Date: 29 September 2022
To: All Plan Holders
Subject: ADDENDUM NO. 2
Project: TROY UNIVERSITY HWY 231 ENTRY SIGN
Job #: SSL# 22016
TROY BID# 22-038
From: Cody Smith

The Plans and Specifications dated September 2022 of the subject project, and any subsequent addenda are amended as follows: (Where there are conflicts between the plans and specifications and the addendum, this addendum shall govern)

5 SCREEN WALL GATE ELEVATION
1/4" = 1'-0"

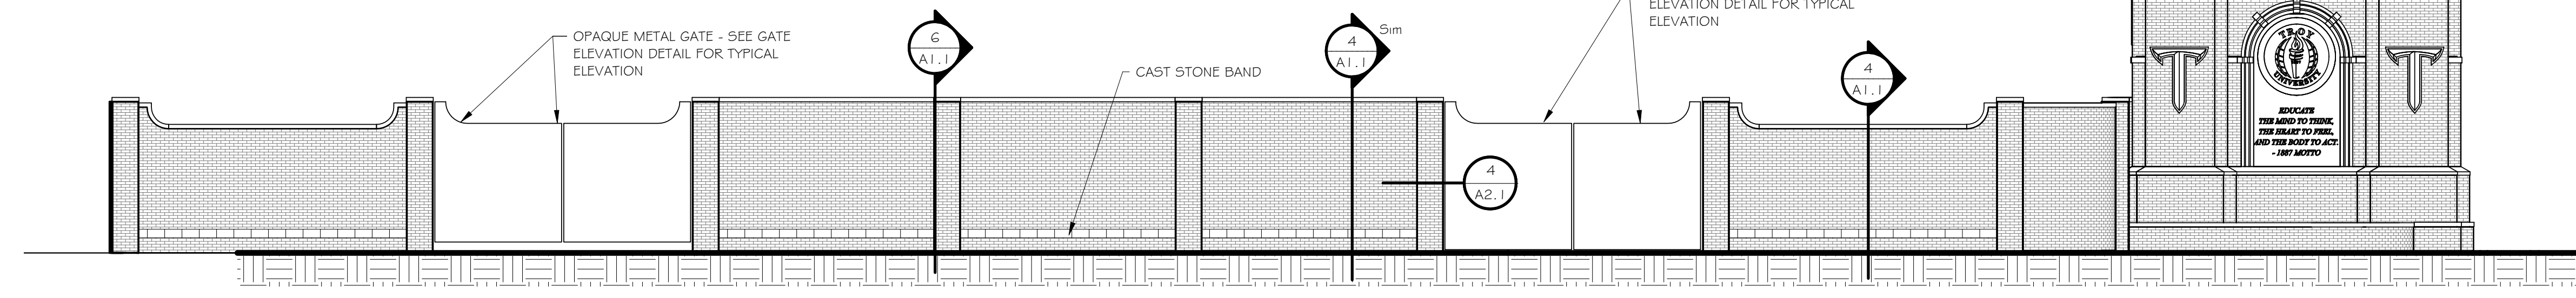
Item 2: Refer to Drawing A1.1 and replace with attached. Added Drop Rod to Gate Elevation.

Sheet Number
A4.1

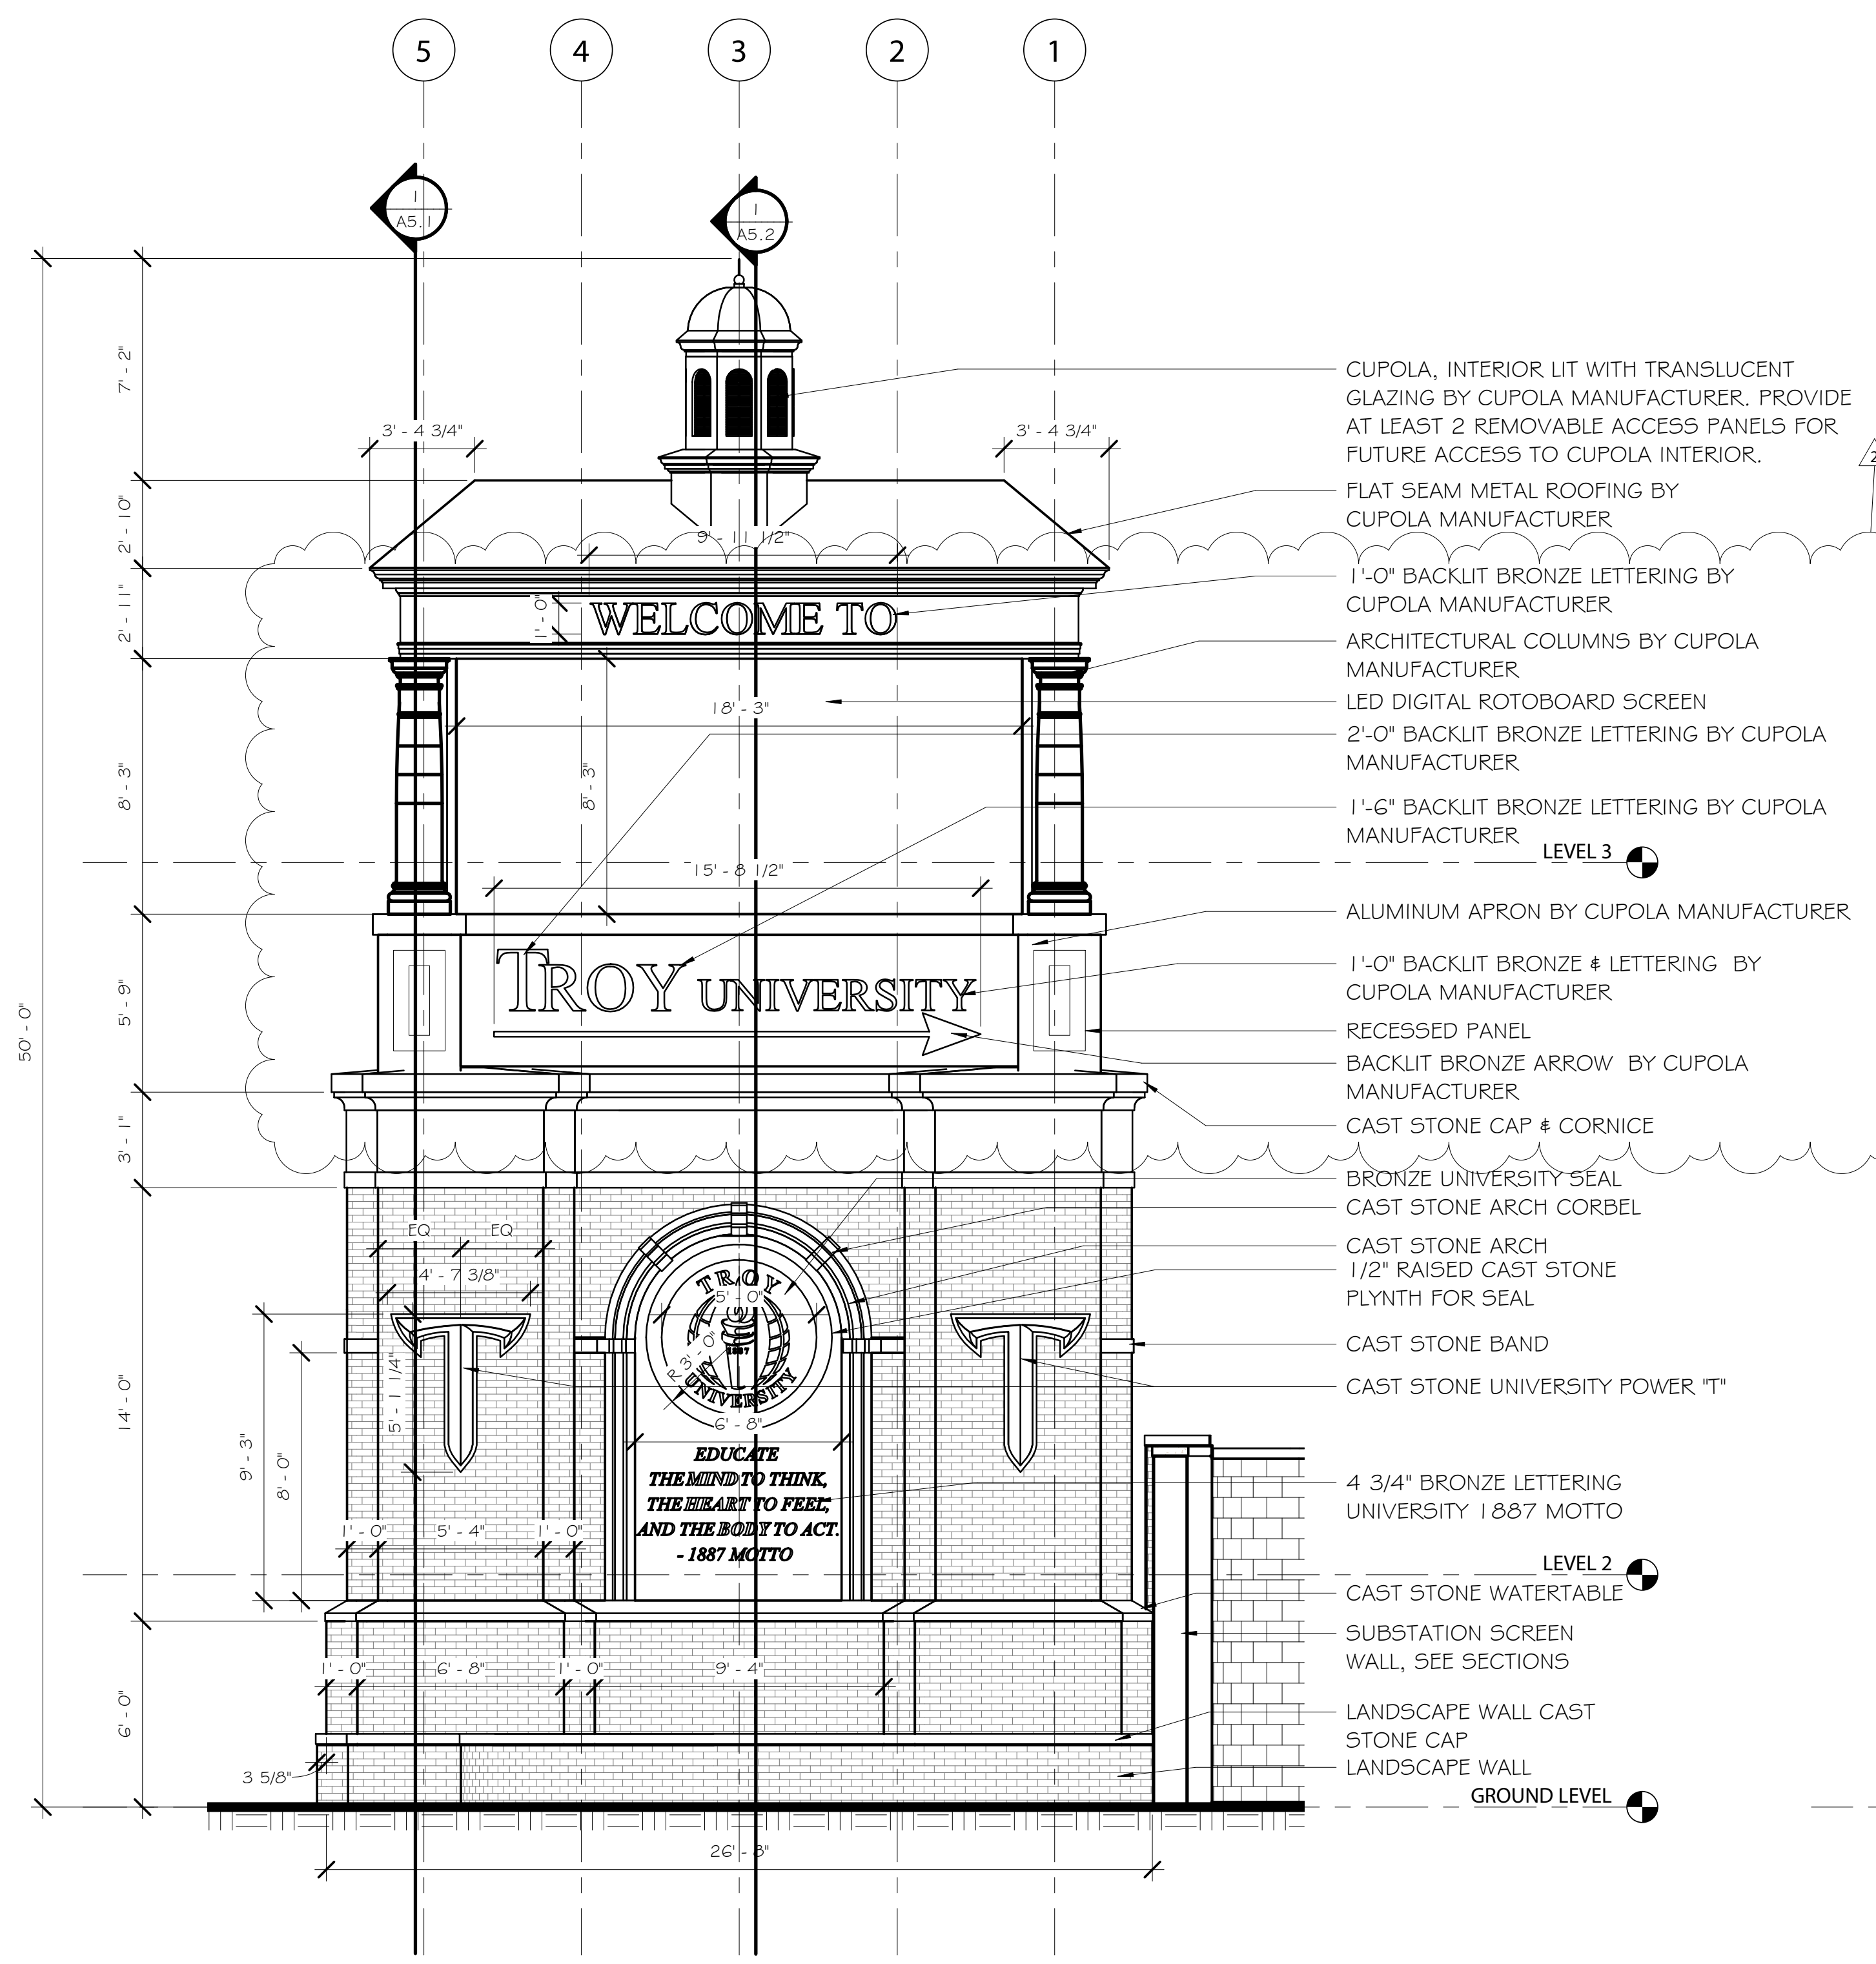
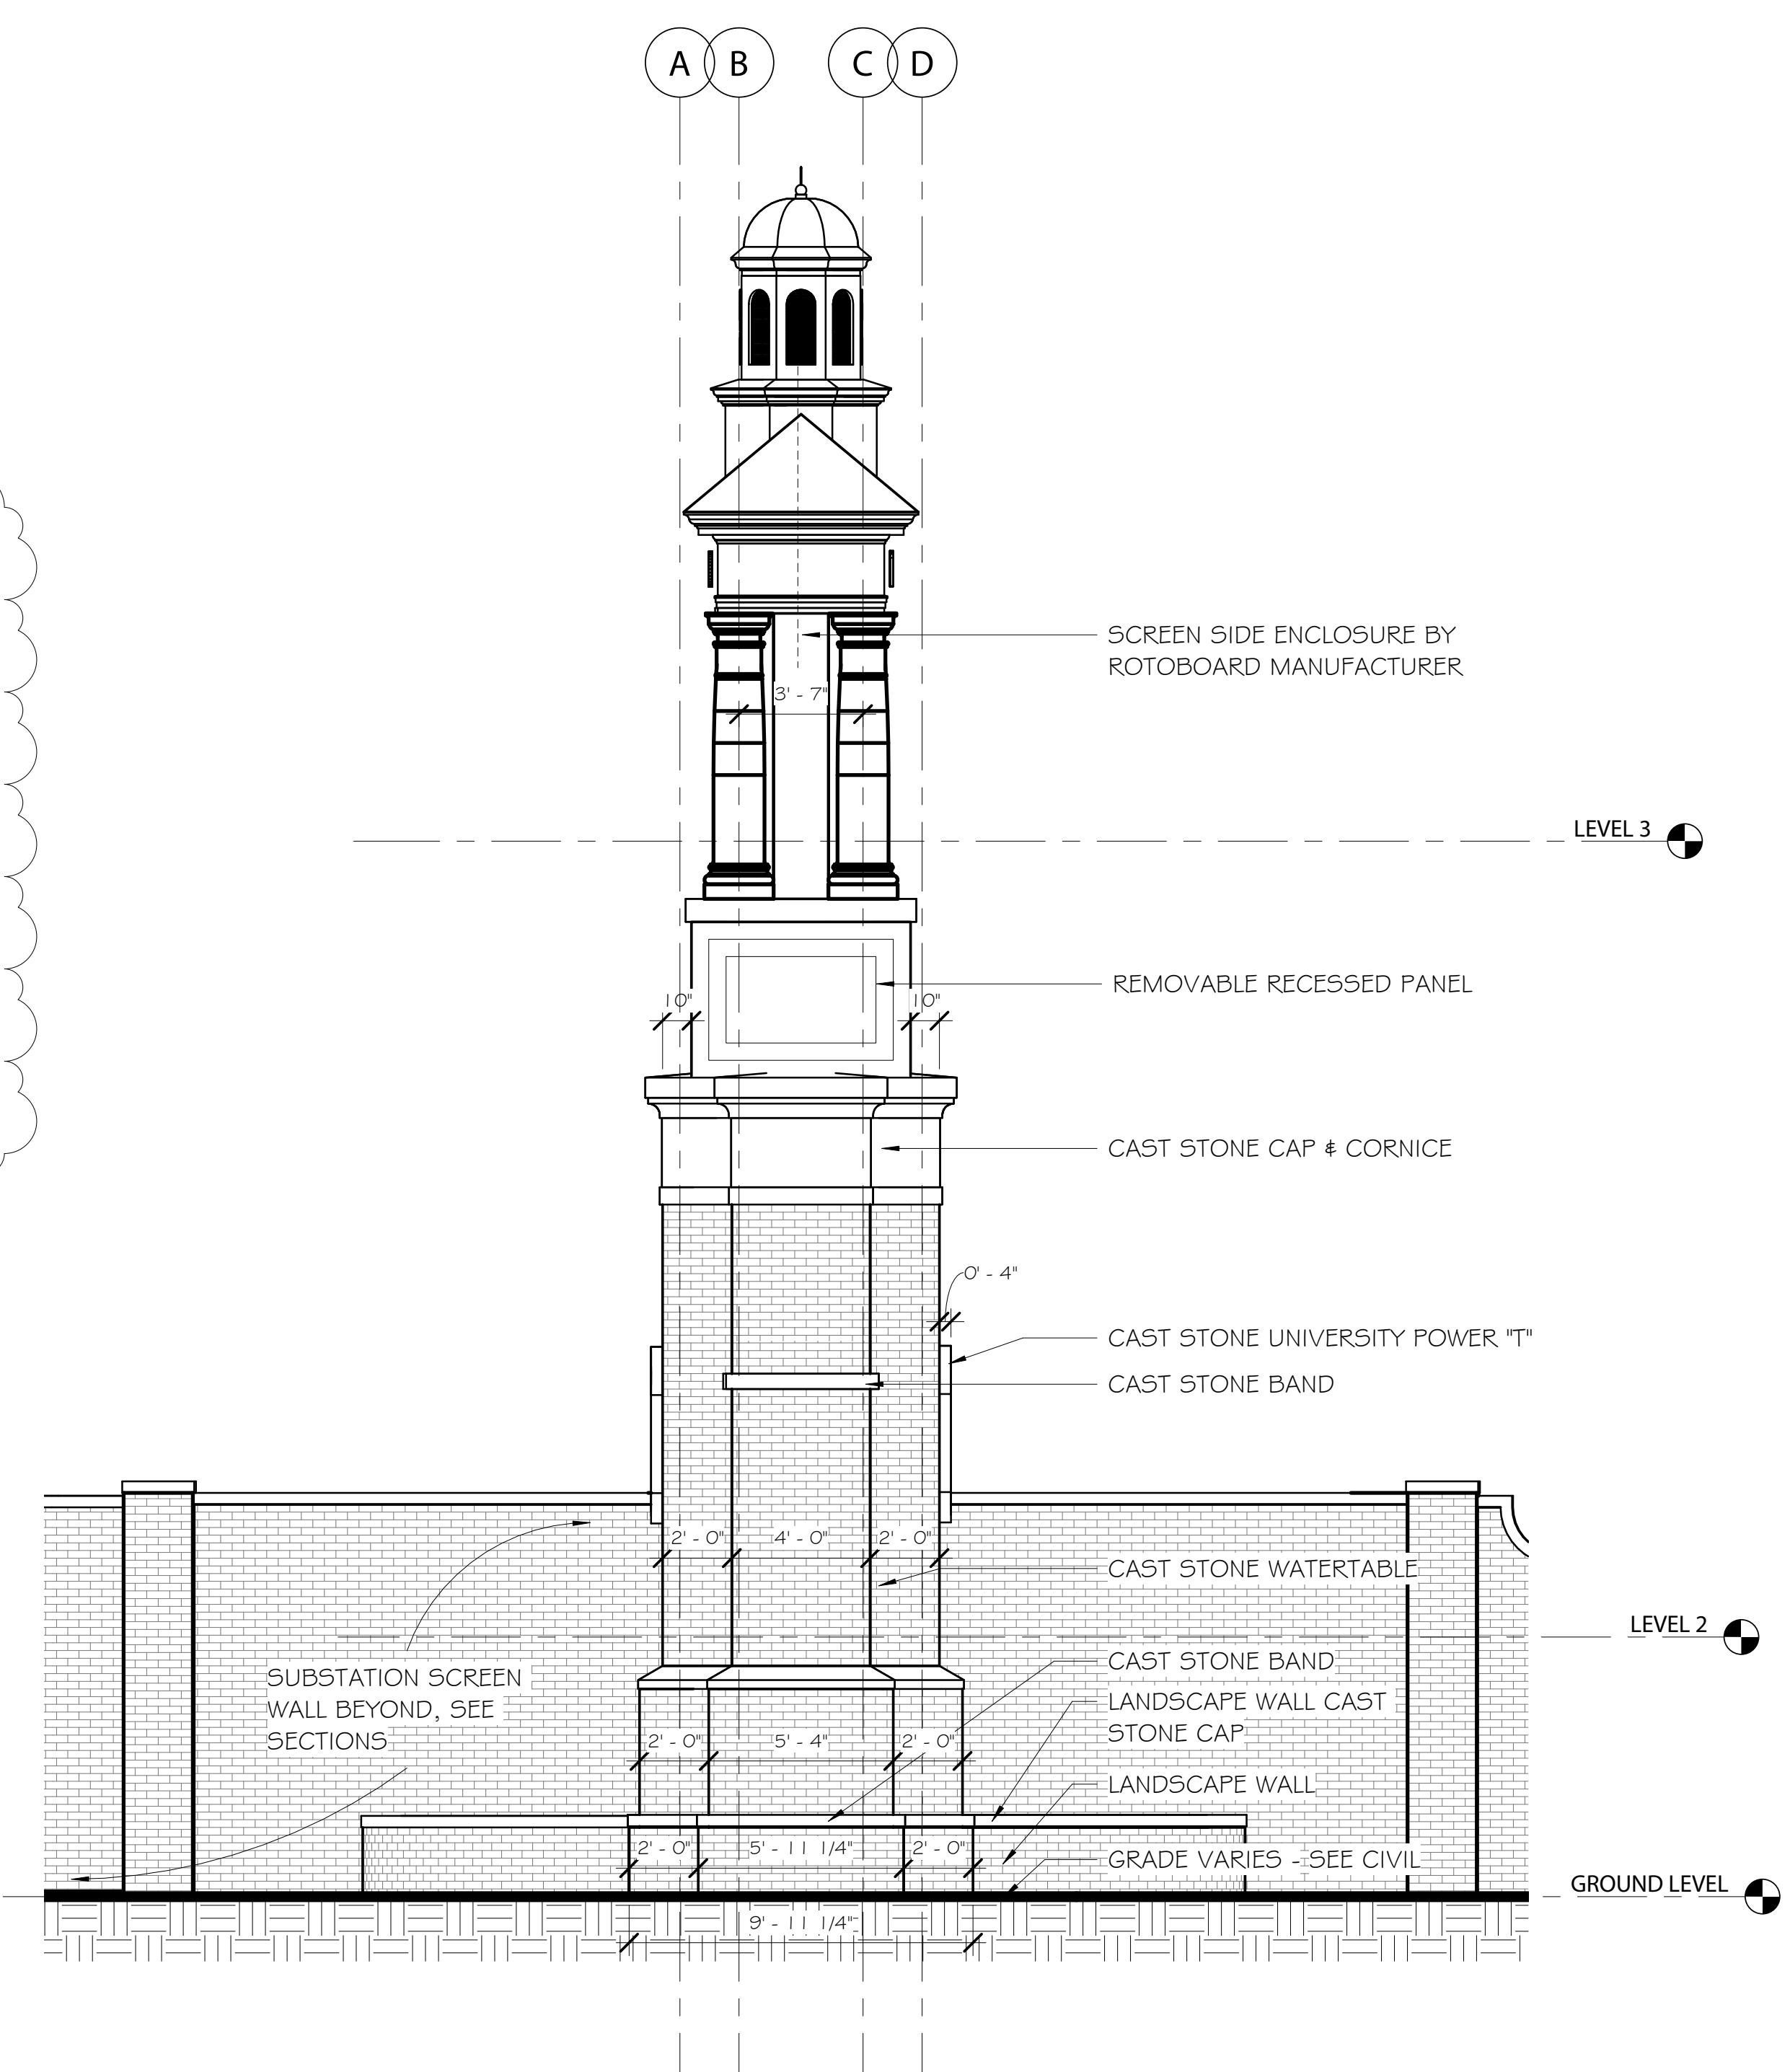
Item 3: Refer to Drawing A4.1 and replace with attached. Updated Troy University lettering and arrow.
